Planning Commission Regular Meeting
Tuesday, September 3, 2024 7:00 PM

CITY OF HICKMAN
STAFF REPORT FOR PLANNING COMMISSION
SEPTEMBER 3, 2024 MEETING

SHEET 4 OF 7

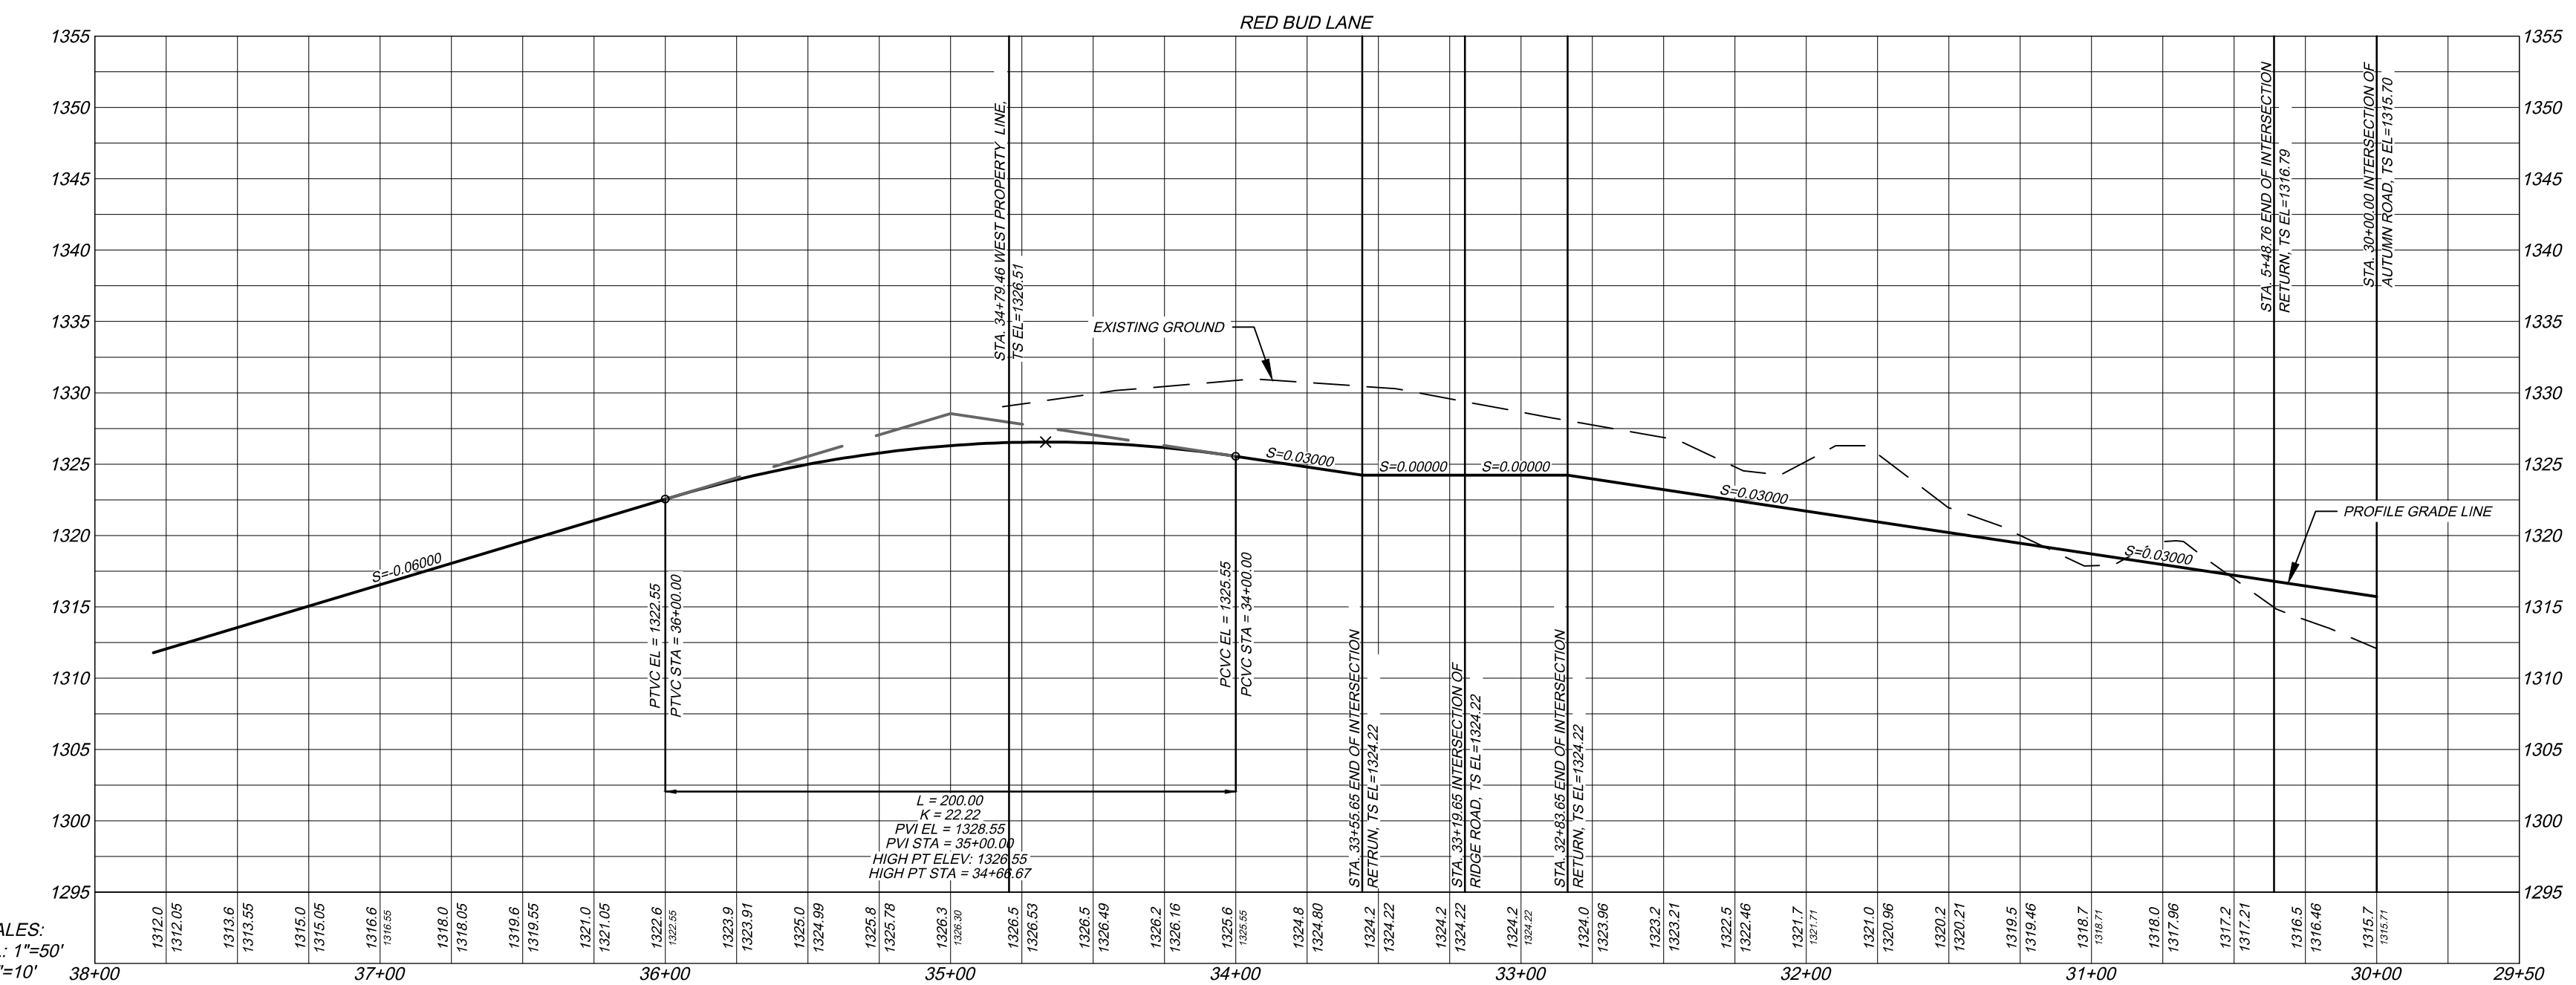
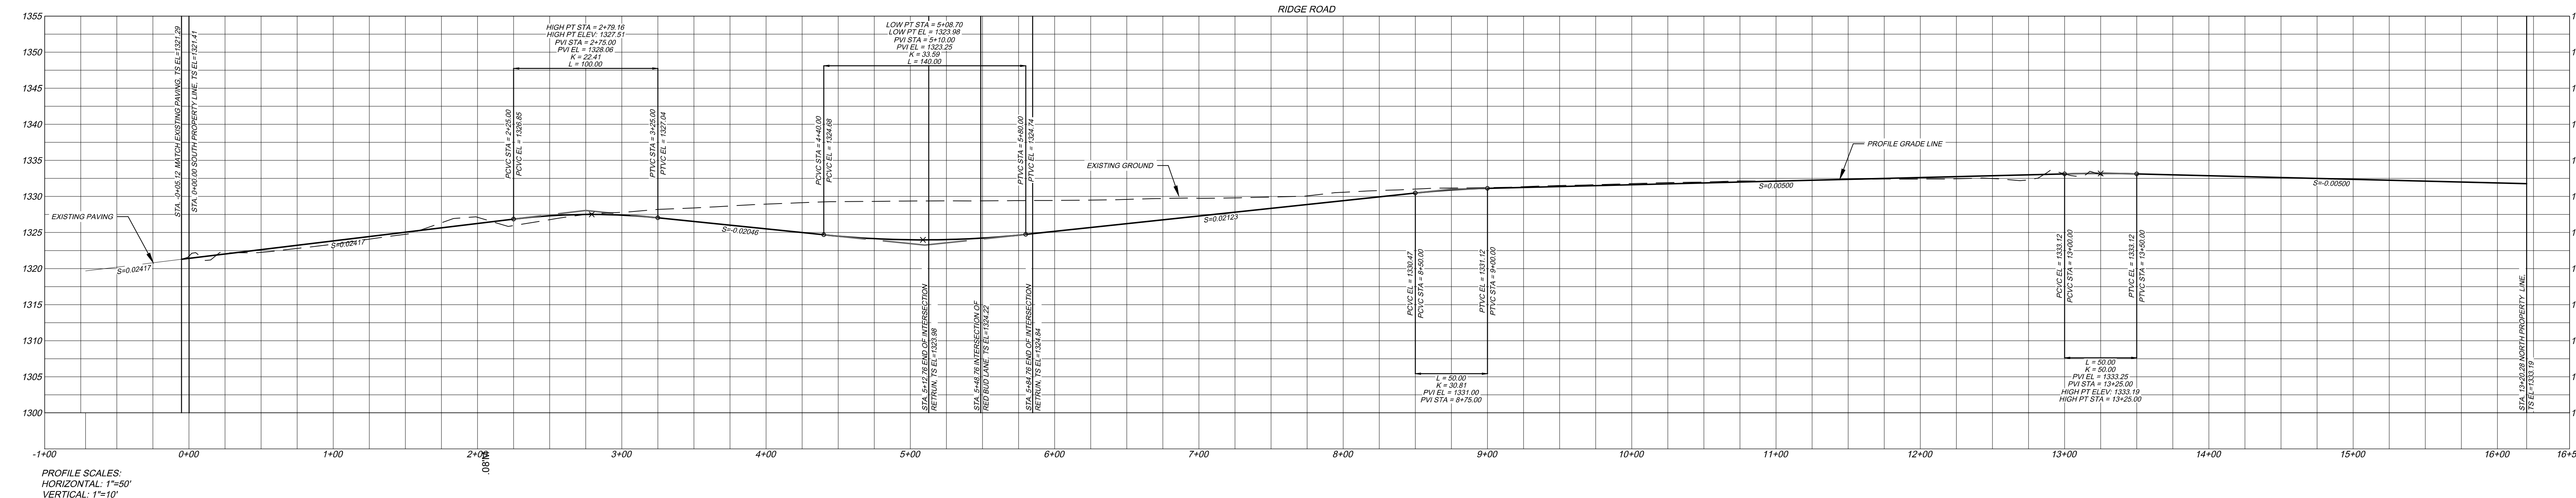
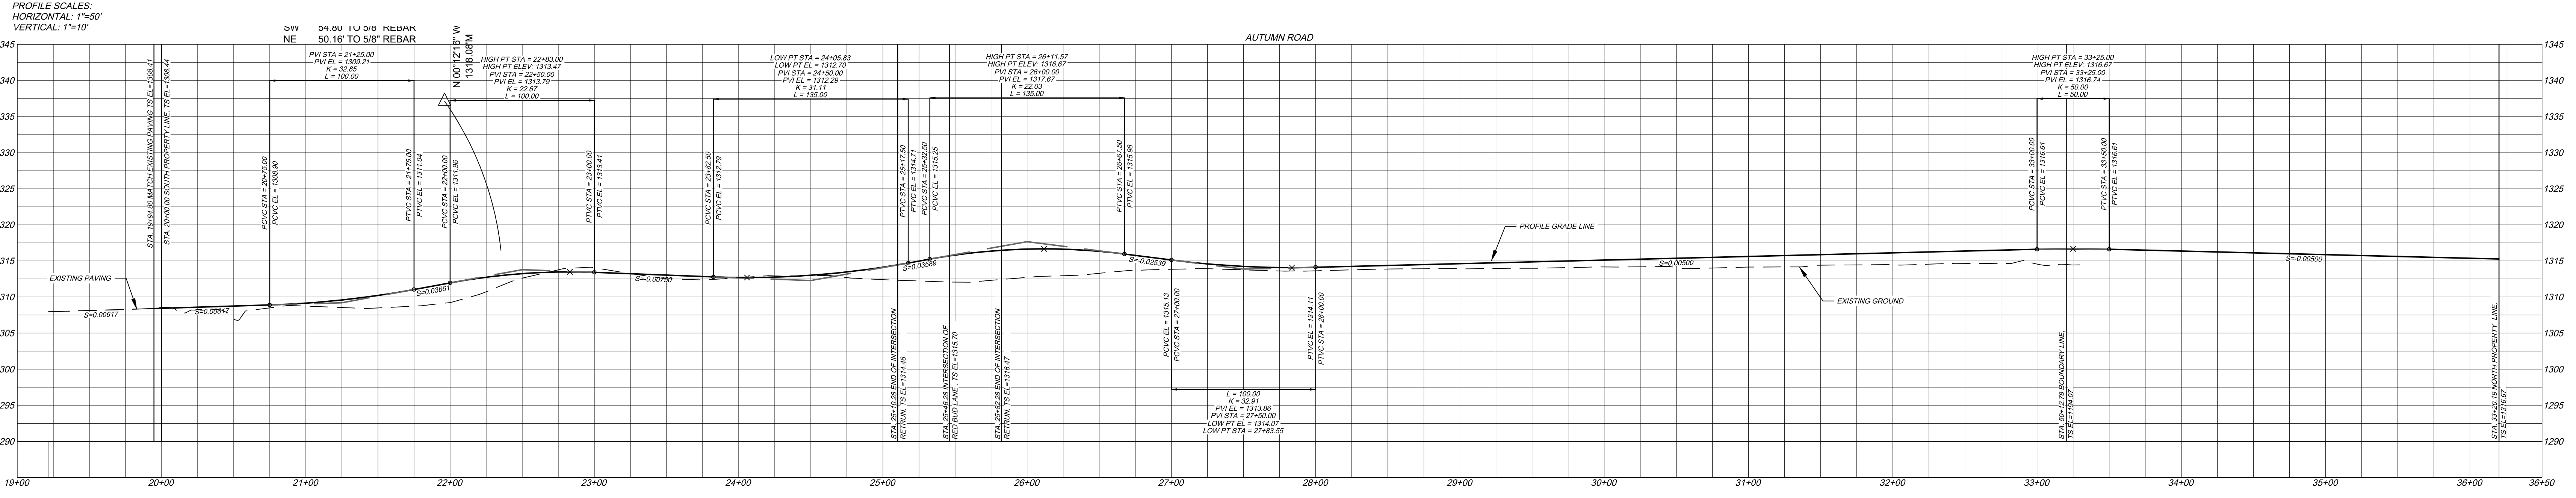
8. *On Sheet 6, the paving profiles don’t meet our min K values – however ours are for a 30 mph zone. (Does this meet City of Hickman Standards)*
 9. *On Sheet 4 of 7, sub basin D1 has no cover description/curve number in the table?*
